EDMS NO. 1973031	REV. 0.1	VALIDITY DRAFT
----------------------------	--------------------	--------------------------

REFERENCE LHC-TC-EC-0014

ENGINEERING CHANGE REQUEST

First Phase of Installation of Low-Impedance Secondary Collimators (TCSPM) in IR7

Figure 1 — 3D view [5] of the TCSPM collimator (smarTeam code: ST0948103), showing an extremity of the jaw with the embedded BPM, the “third” BPM for orbit measurements in the plane orthogonal to the collimation plane, and the new tapered transitions made of MoGr.

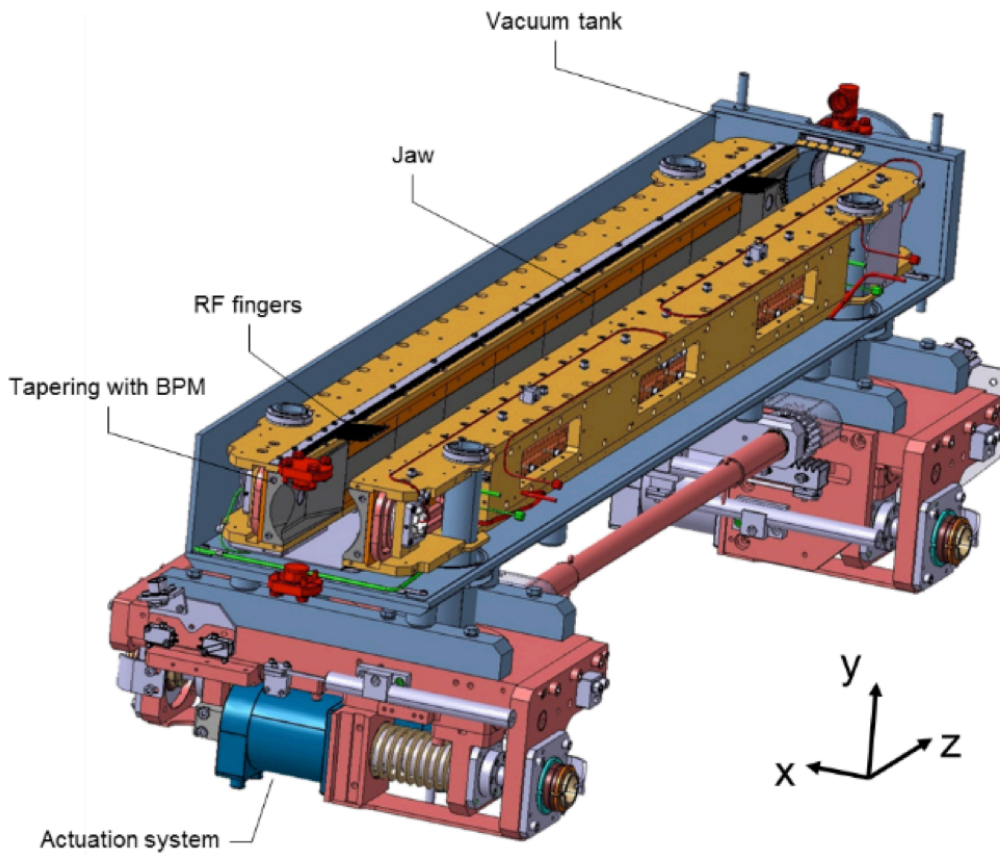
The present TCSPM design [5] (see Figure 1) is an evolution of the present TCSGs [1]; among the most noticeable differences, there are material and coating of the jaw, and the presence of Beam Position Monitors (BPMs). The BPMs are embedded in the jaw and shall be added in the database with the same notations used for the present TCTP and TCSP collimators. Other features are described in [7]. In fact, the design foresees jaws made of a composite material (MoGr) obtained from Molybdenum and graphite, chosen for its similar robustness and superior impedance characteristics with respect to the jaw material of the present TCSGs, in particular since a thin coating layer of Mo will be deployed. The collimator jaws are equipped with BPM button pick-ups, for an easy determination of the beam closed orbit at the collimator and fast and precise alignment of the jaws. A third BPM is installed on the tank, to measure the beam position on the axis orthogonal to the one of cleaning.
